Errata- StationPro II Operating and Assembly Manual
(revised 12/11/2010 - corrections to manual version 5/07/2010)

Page 45:

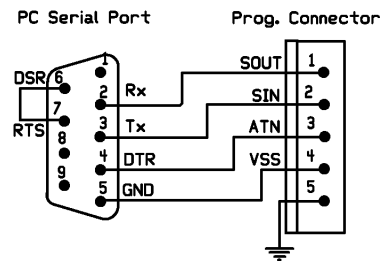
In Step (e), the drawing has the retaining clip shown on the wrong side of the program connector. Please correct the drawing or replace it with the following:
